# Los Alamos National Laboratory

Date: February 29, 1996  
Refer to: EM/ER:96-086

**SUBJECT: RESPONSE TO THE NOTICE OF DEFICIENCY (NOD) FOR OPERABLE UNIT (OU) 1079**

Fig. 3. 1950 oblique aerial photo looking northwest towards TA-32.

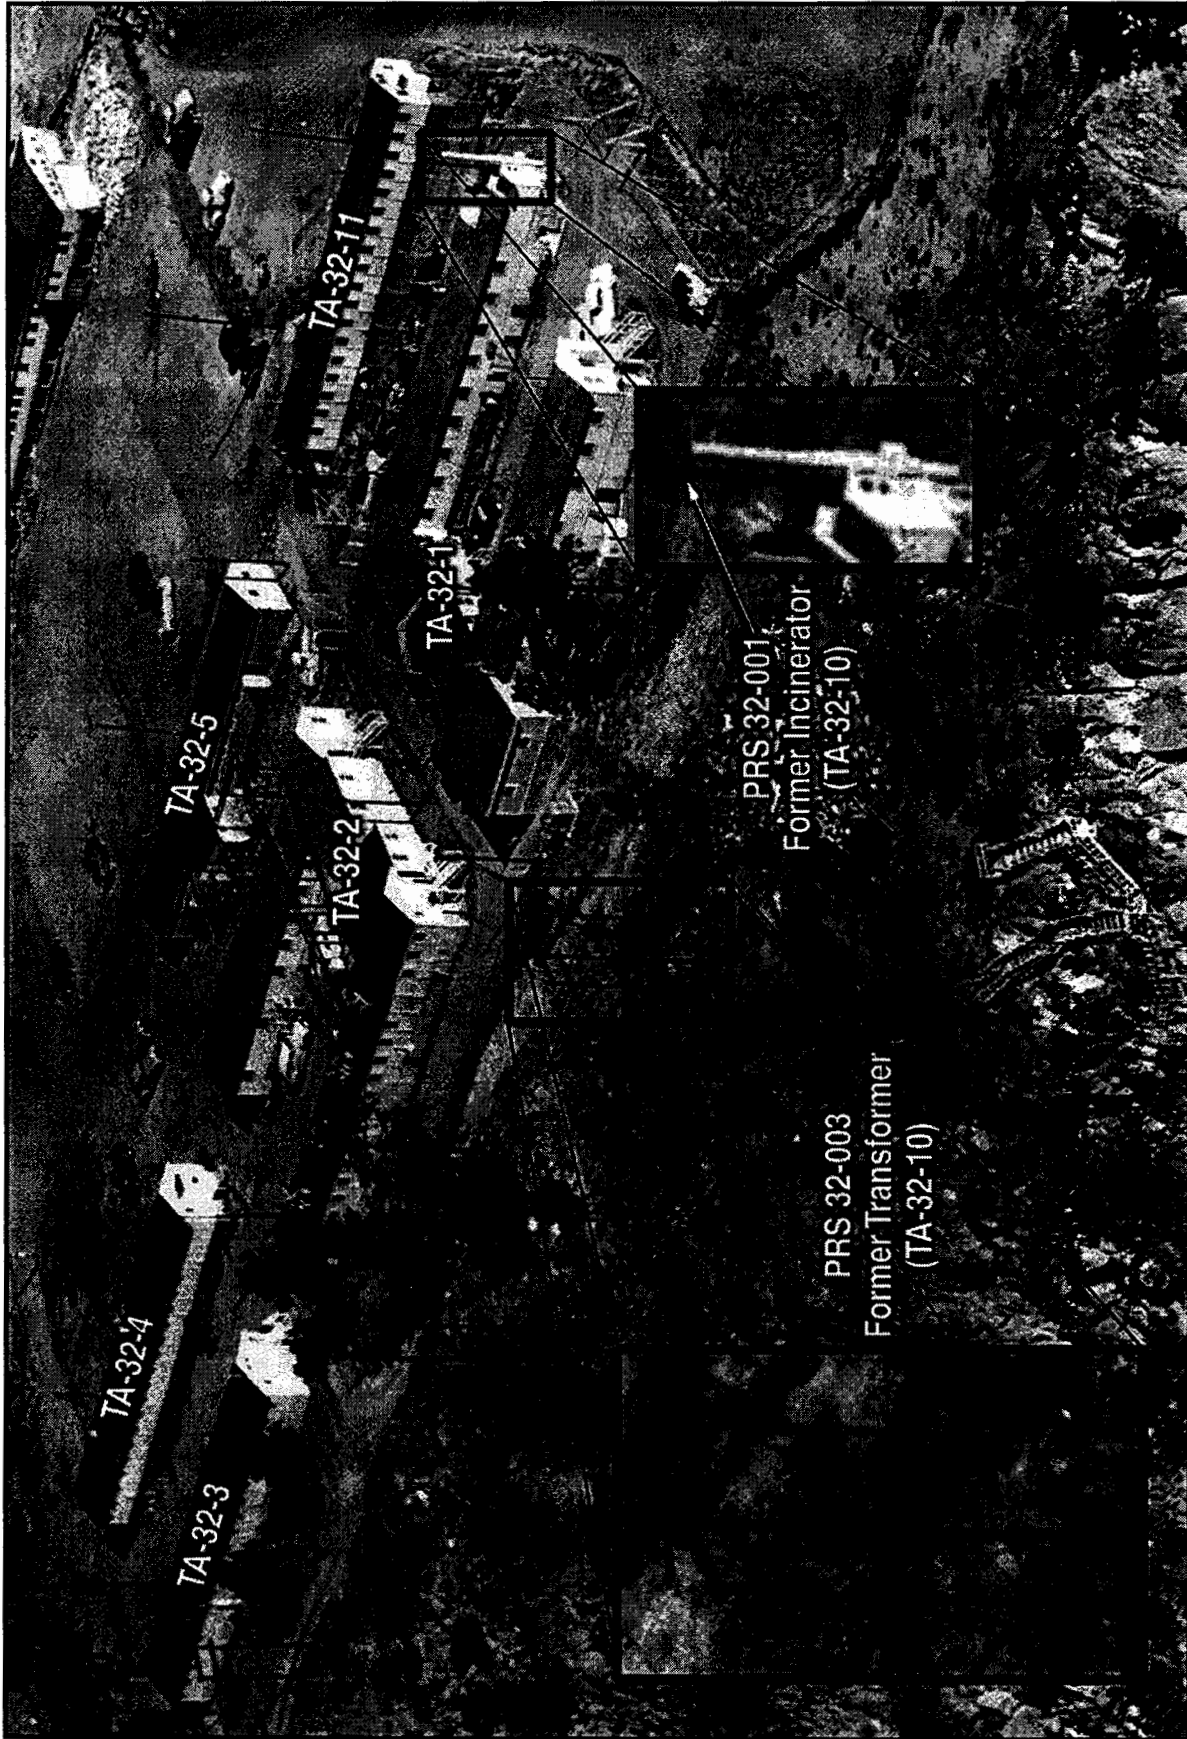
a. LANL indicates that two samples were collected "near" the wood debris pile. Also, "the former transformer location is currently beneath the asphalt parking area of the Los Alamos County Roads Division." Leaks or spills from the transformer would have contaminated the soil beneath the transformer, which is the most appropriate location to collect samples. EPA recommends that LANL explain why soils near the wood debris pile were selected and why the soil beneath the asphalt at the former transformer platform location was not sampled.

a. As described in Subsection 4.3.1 of the RFI report, the location of the wood debris pile was originally believed to be the remains of PRS 32-002(a). However, archival engineering drawings and aerial photographs located after the Phase I investigation indicate that the wood debris pile is more likely the remains of the platform pad for the former transformer station, PRS 32-003 (Figs. 3 and 4). The archival engineering drawings indicate that PRS 32-002(a) is actually located on a topographic bench southeast of the wood debris pile.

While it was stated in the RFI report that the former transformer location is currently beneath the asphalt parking area of the Los Alamos County Roads Division, the new archival evidence shows that this statement is incorrect. Engineering drawing A5-C117 shows the transformer station to contain three barrel transformers on a wooden pad approximately 60 ft from the edge of Los Alamos Canyon (Fig. 2). A 1950 oblique aerial photograph looking northwest towards TA-32 clearly shows power poles near the mesa edge and a three pole transformer (a pad containing three barrel transformers) (Fig. 3). During a field reconnaissance visit on January 9, 1996, the power poles along the mesa edge, which had been cut off at or just above ground level, were located. In addition, the wood debris pile was found to be located within 7 ft of the base of three poles that were cut off and covered by heavy brush. All of this new information confirms that the location of the wood debris pile is the approximate location of PRS 32-003.

Because the Phase I samples were collected at appropriate locations to characterize PRS 32-003 and its outfall, Phase II sampling will focus on defining the extent of the PCB contamination detected during the Phase I investigation.
